UpRight
Product Support**SERVICE BULLETIN SB98.12****Machines/Models: AB46****Serial Numbers: 1000-1474**

PURPOSE: Restrict the movement of the Emergency Hand Pump Lever.

Figure 1

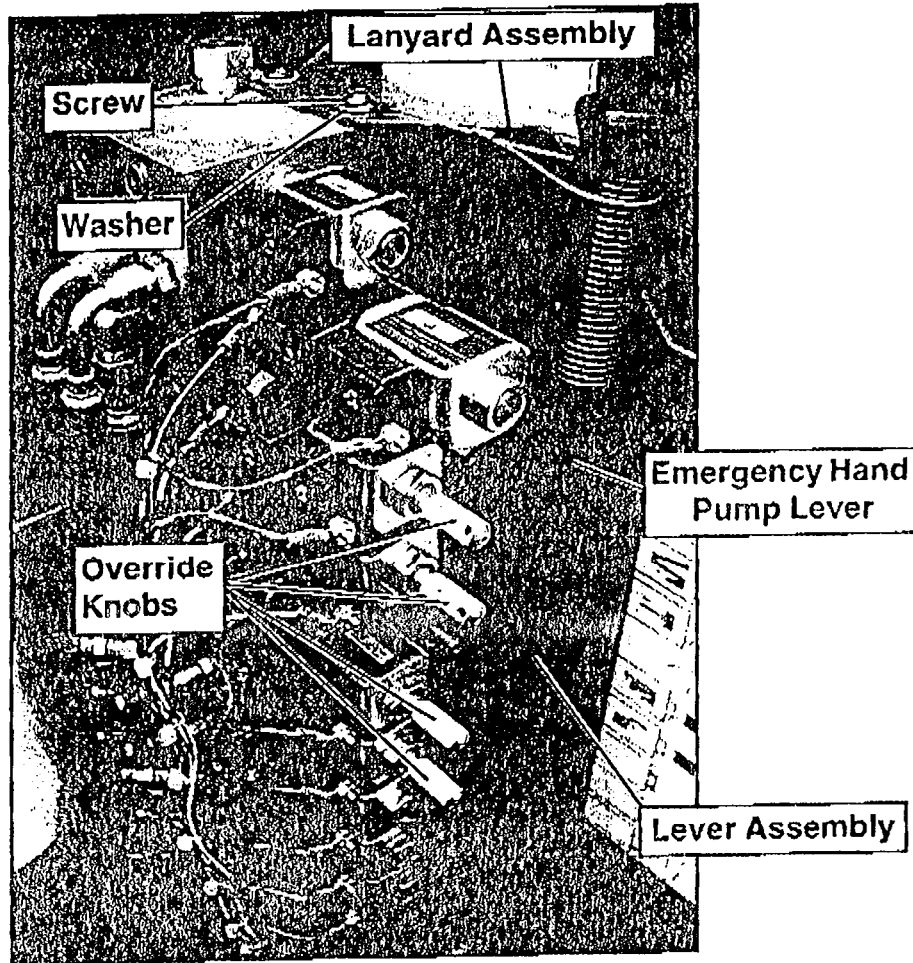
OPERATION REQUIRED: Remove and replace the Lanyard Assembly from the Manifold Bracket.

1. Remove the Lanyard Assembly from the Emergency Hand Pump Lever. See figure 1.
2. Using a 5/16" allen wrench, remove the Screw, Washer, and Lanyard Assembly as shown in figure 1. Discard existing Lanyard Assembly.
3. Assemble new Lanyard Assembly (#063783-002) using existing hardware. Apply a small amount of Lockite 242 to the retaining screw and install.
4. Torque the retaining screw to 13 ft/lbs (18 Nm).
5. Raise the Lever Assembly to the stowed position, place the Lanyard Assembly (#063783-002) over the Lever Assembly handle.
6. Cycle the Override Knobs on the Valves to relieve the pressure from the pump.
7. Perform a full function test including all of the Emergency Override functions.
